RE: **Monterey Place Apts**
2306-2320 Central SW
Grading Plan Stamp Date: 11/13/19
Drainage Report Stamp Date: 11/13/19
Hydrology File: J12D030

RE: Monterey Place Drainage Submittal for Building Permit (Hydrology File: J12D030)

Thank you for the comments you provided on the Grading and Drainage Plan for the Monterey Place Apartments project (PR-2019-002331 and CPN 631982) on October 01, 2019. Below in blue are SEH's responses to Comments 1-4 for "Prior to Building Permit and Work Order."

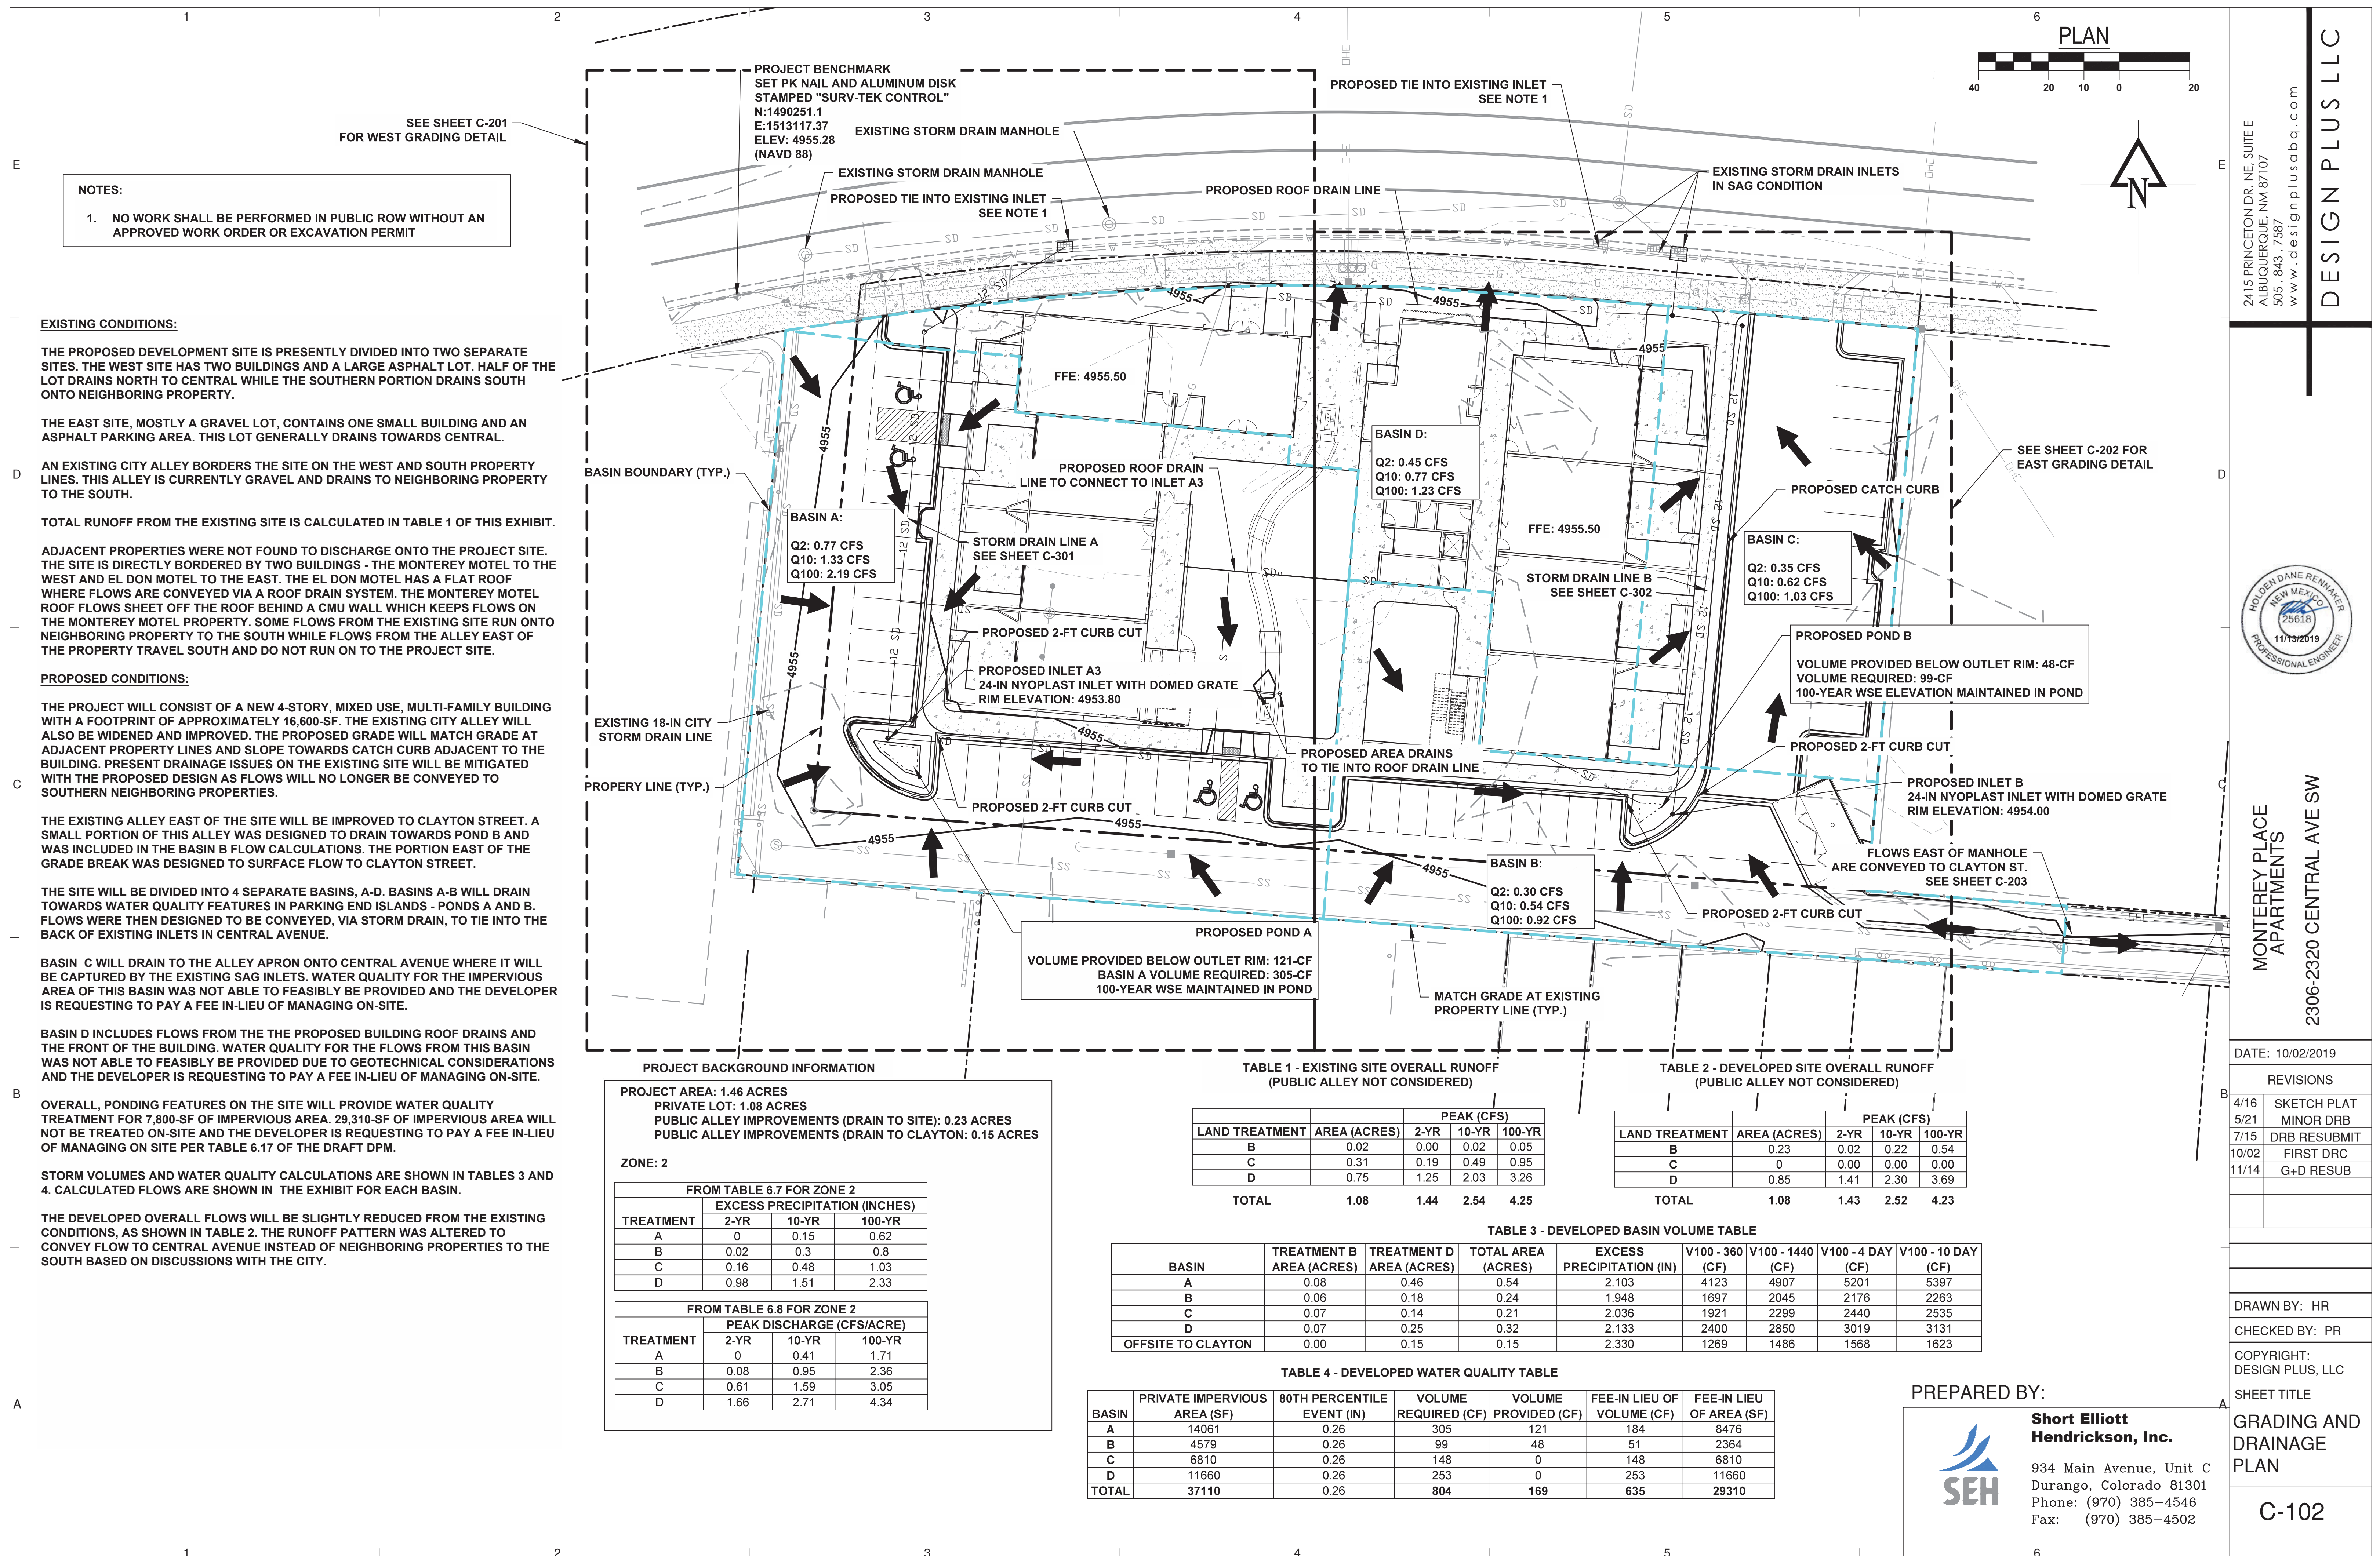
1. Remove all "Conceptual/Not for Construction" markings and stamp, sign and date the plan.
[All markings were removed and the plan stamped and dated.](#)

2. All drainage calculations and findings, to include those presented in the response letter, need to be provided in a bound report, stamped/signed by the engineer.
[The calculations and findings have been included in a bound report that is stamped/signed.](#)

3. As a reminder, if the project total area of disturbance (including the staging area and any work within the adjacent Right-of-Way) is 1 acre or more, then an Erosion and Sediment Control (ESC) Plan and Owner's certified Notice of Intent (NOI) is required to be submitted to the Stormwater Quality Engineer (Doug Hughes, PE, jhughes@cabq.gov, 924-3420) 14 days prior to any earth disturbance.
[An Erosion and Sediment Plan and Notice of Intent will be submitted 14 days prior to earth disturbance.](#)

4. Payment of the Fee in Lieu (Amount = 635CF x \$8/CF = \$5080, per sheet C-102) of onsite management of the SWQV must be made. Include a copy of the paid receipt when resubmitting.
[The fee was paid and a copy of the paid receipt was included with the resubmittal.](#)
